**SAFETY  
RECALL**

**SR14-10**

DATE :	APRIL 2014	SECTION :	06 - Electrical
SUBJECT:	12VI5 POWER CABLE CRIMPING [H Series]

Figure 3 - CB8 end

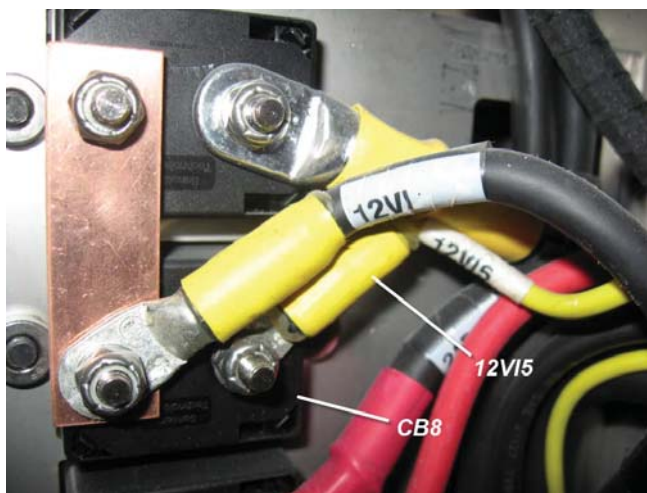
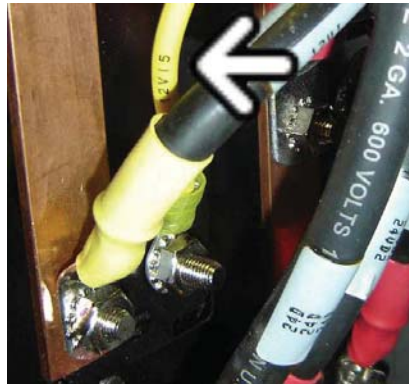
2. Behind the circuit breaker junction panel (fig. 3), locate wire **12VI 5** connected to **CB8** (Fig. 2&6).

3. On circuit breaker end, cut cable 12VI5 just above the terminal.
4. Strip wire and install ring terminal #560086.

Figure 7 - VECR connections

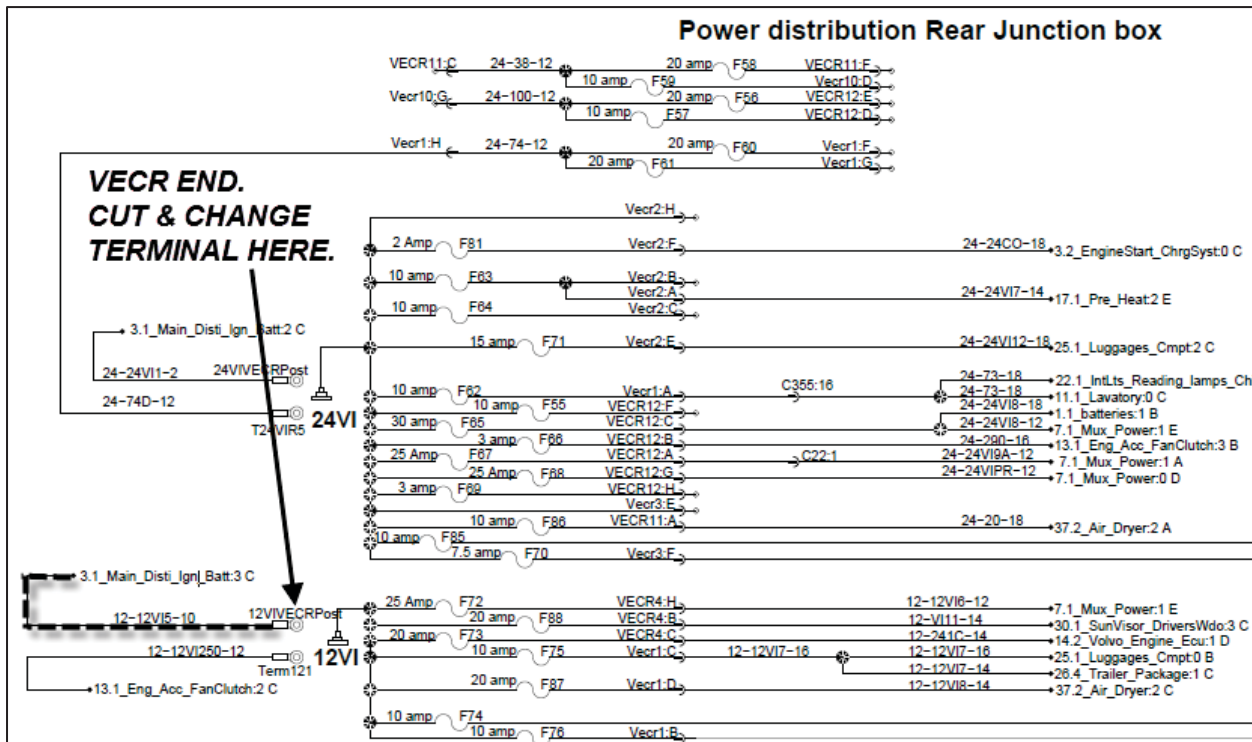
5. On VECR end, cut cable 12VI5 just above the terminal. (Fig 5&7)
6. Strip wire and install ring terminal #563536.
7. Test vehicle functions to ensure proper operation of vehicles systems.
